| Project                      | <b>IEEE 802.16 Broadband Wireless Access Working Group</b><br>< <a href="http://ieee802.org/16">http://ieee802.org/16</a> >   |  |
| Title                        | Consolidation on the description of the CSI symbol and frame  |  |
| Re:                          | 80216h-06_011: Working Group Review: P802.16h Working Document (2006-04-07)   |  |
| Abstract                     | Text modification on the ICSI frame description   |  |

3  
4 **Figure hxx: CSI symbol transmission and receiving**

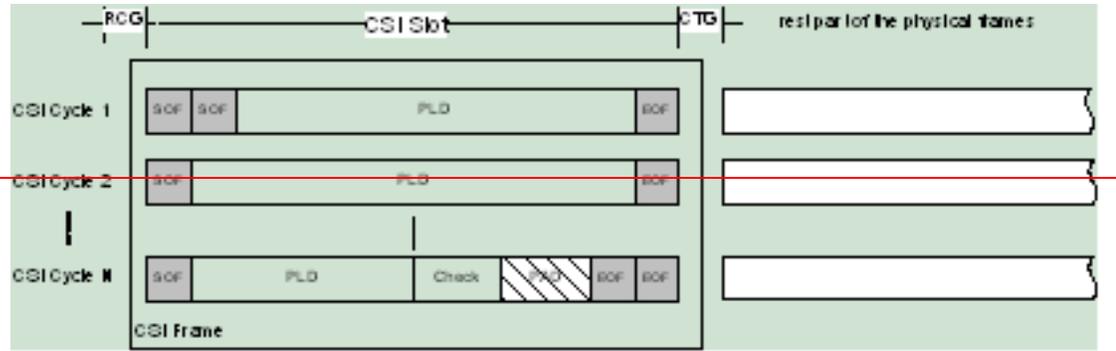
2 [Insert the figure at the end of section 15.2.1.1.3 as indicate:]

**Figure h15—CSI frame construction with no less than 4 symbols in one slot**

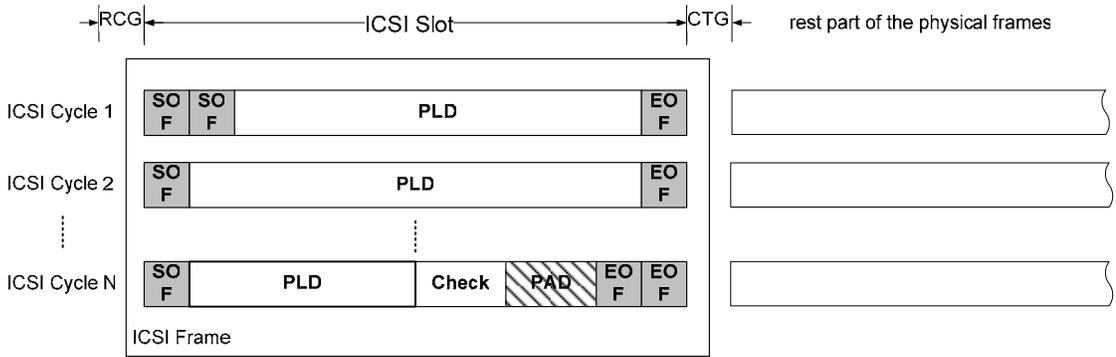
7 ~~The CSI frame is broadcasted from the base station to the coexistence neighbor's subscriber station. within They are~~  
 8 ~~loaded into~~ serialized CSI slots ~~fragmentally~~. ~~It~~The CSI frame consists of power keying energy symbols as the basic  
 9 element and carry the information from BS to the coexistence neighbor's SS. The CSI frame has the <SOF> symbols  
 10 and <EOF> symbols as the boundary of slots ~~when there is more than 4 symbols in each CSI slot,~~ and ~~two~~  
 11 consecutive <SOF> and <EOF> indicate the ~~message signaling frame~~ boundary. ~~Each CSI frame shall have 8 bits~~  
 12 ~~cyclic redundancy check(CRC) (Polynomial "X<sup>8</sup>+X<sup>2</sup>+X+1") appendant to check the validity of the information~~  
 13 ~~carried in the CSI frame. In case when the last slot of the signaling frame have not been used up with the CRC and~~  
 14 ~~<EOF>, Pad- which is filled with symbol one before the check between the CRC and double <EOF>, shall be only~~

15 ~~necessary to extend the slot to equivalent length it shall be filled with symbol one in the rest part of last slots which have~~  
 16 ~~not enough payload and checking appendant.~~ CSI frame should be continuously carried in the serialized CSI slots  
 17 during the whole CSI frame structure. ~~Each CSI frame shall have 8 bits cyclic redundancy check (Polynomial~~  
 18 ~~"X<sup>8</sup>+X<sup>2</sup>+X+1") appendant to check the validity of the information carried in the CSI frame.~~The basic structure is  
 19 shown below:

**Figure h15—CSI frame construction with 1 symbol in 1 slot**

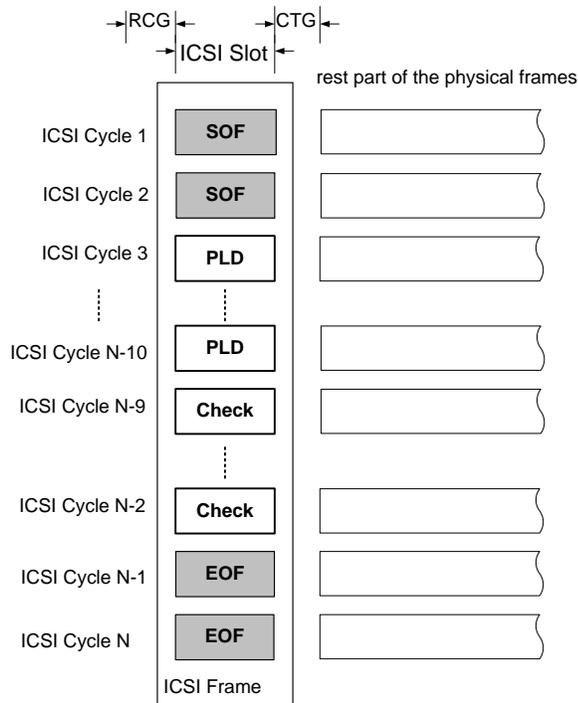
25 When there is more than 4 symbols in each CSI slots, there will be a <SOF> and an <EOF> at the beginning and the  
 26 end of the slots respectively. All the <SOF> and <EOF> will be dropped when reassembling the payload of the CSI  
 27 frame.

7  
8  
9 **Figure h16—CSI frame PLD**

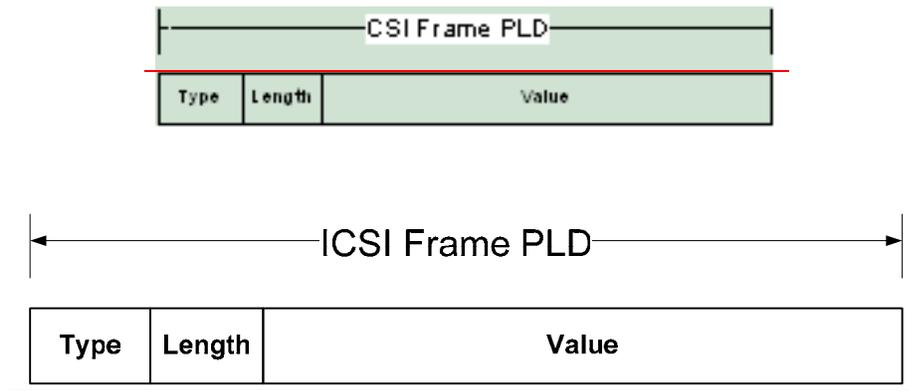
4 The PLD (payload) part of the CSI frame should be divided into TLV aspect. TYPE indicate the type of the payload,  
 5 LENGTH correspond to the number of symbols/bits contained in the VALUE portion. (TYPE and LENGTH is 1 octet  
 6 each.)
